Digital Recovery Sequencer

Materials & Manufacturing Directorate

3 Aug 2020

Incident Digital Recovery Sequencer (DRS)

Capacitor C262

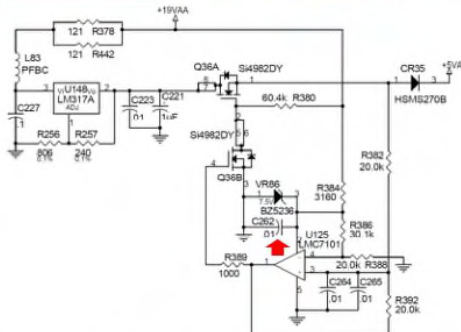
- 0.01 μF ceramic SMD capacitor.
- Function: bypass/decoupling capacitor for op amp U125's 7.5 V power supply terminals.
- Partially dislodged from solder pads.
- Each capacitor terminal is making electrical contact with its respective pad.
- Direct, localized impact the most likely cause. (No other components had a similar failure.) Hypothesis: since C262 is adjacent to mounting hole, it was damaged during installation or removal of PWB by accidental direct contact with mounting hardware.

Example: Power MOSFET Q27

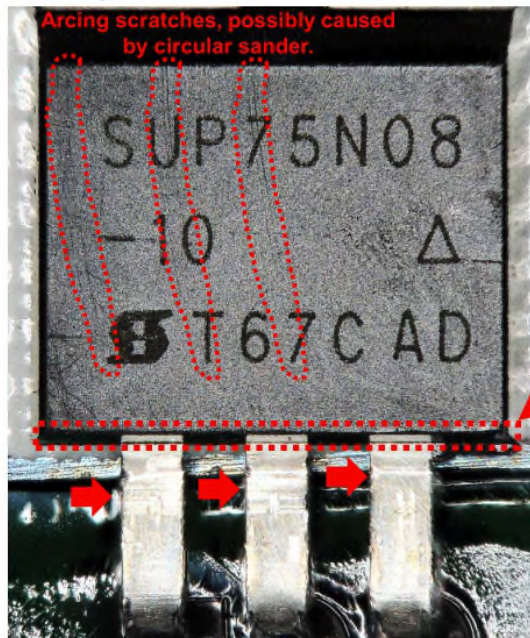
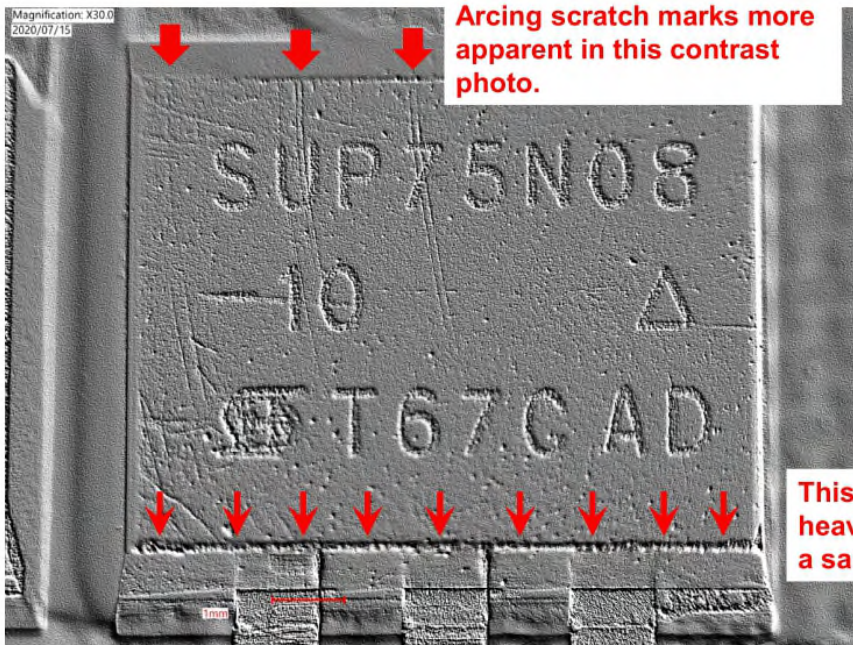
Font and Style of markings match those of genuine components

Top of leads have deep horizontal grooves, possibly caused by a clamp. Other TO-220 devices on PWB do not exhibit these grooves.

This corner (and only this corner) is heavily gouged, possibly caused by a sander.

Power MOSFET Q27 cont.

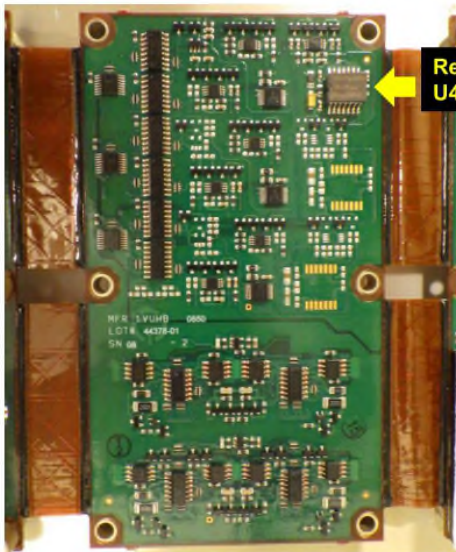
Arcing scratch marks more apparent in this contrast photo.

Better photos and analysis can be performed after components are removed from PWB.

This corner (and only this corner) is heavily gouged, possibly caused by a sander.

Dual Axis Accelerometers – Suspect Counterfeit Components

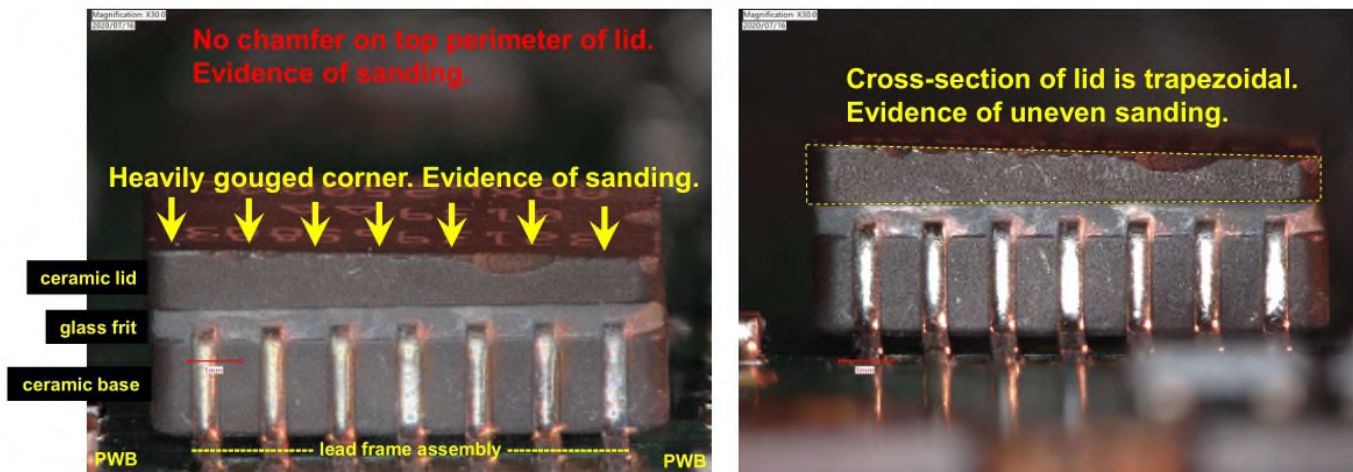
- Analog Devices ADXL250AQC.
- 14 lead Cerpac package.
- Quantity of one on PWB (U41).
- Obsolete.
- AFRL is performing analysis on two ADXL250AQC (U41) chips:

1. Original ADXL250AQC chip mounted on PWB during incident. Removed from PWB by Teledyne after incident. AFRL will refer to this chip as Incident U41.
2. After removal of Incident U41 from PWB, Teledyne installed a replacement on PWB. AFRL will refer to this chip as Replacement U41.

- Both Incident U41 and Replacement U41 are suspected of being counterfeit. More analysis needed.

even the replacement chip is suspected of being counterfeit

Replacement U41 – Suspect Counterfeit Component

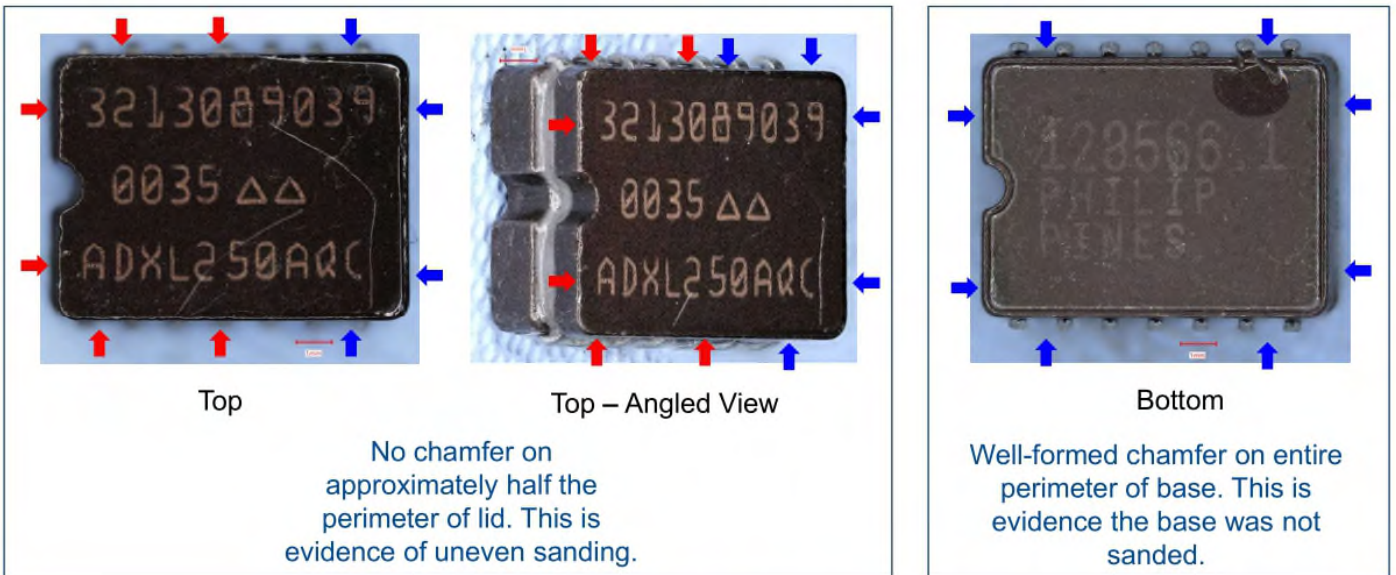
↑ = chamfer ↑ = no chamfer
